ALERT SERVICE BULLETIN

ASB No. AA-08029

SUBJECT: Cargo Door Window Assembly
P/N 205-713-001

FIGURE 1 – WINDOW IDENTIFICATION AREA

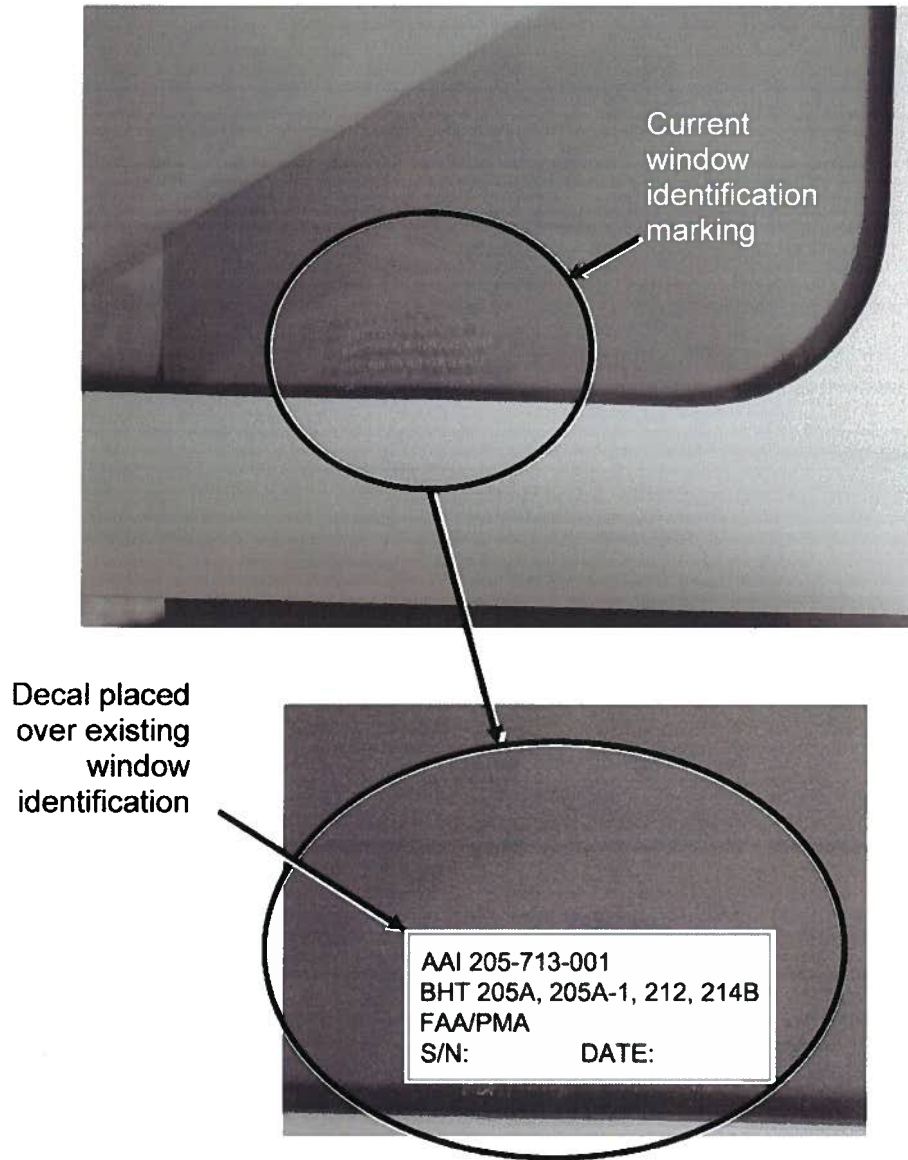
DESCRIPTION: This Alert Service Bulletin is being issued to correct instances of incorrect aircraft applicability data on windows identified with serial numbers 105 – 371. These windows were misidentified with UH-1A, UH-1B and UH-1H applicability.

1. Upon receipt of this bulletin, determine by part number and serial number if affected window has been purchased. If window is affected, contact AAI Customer Support / Sales for decal P/N 099-091-020.
2. Upon receipt of decal, locate Cargo Door Window part number/serial number identification block. (See Figure 1.)
3. Clean window surface using a mild, non-abrasive soap, such as Brillianize by Norel Plastic, and clean, particulate-free water. Use bare hand to carefully feel and dislodge dirt, salt or other contamination. Dry with a clean, damp chamois. A soft tissue may be used, providing care is taken not to continue rubbing after plastic is dry.
4. Apply decal (Figure 2) to window, covering incorrect window identification information.
5. Annotate records to indicate accomplishment of this bulletin.
6. Return aircraft to service or window to stock, as applicable.
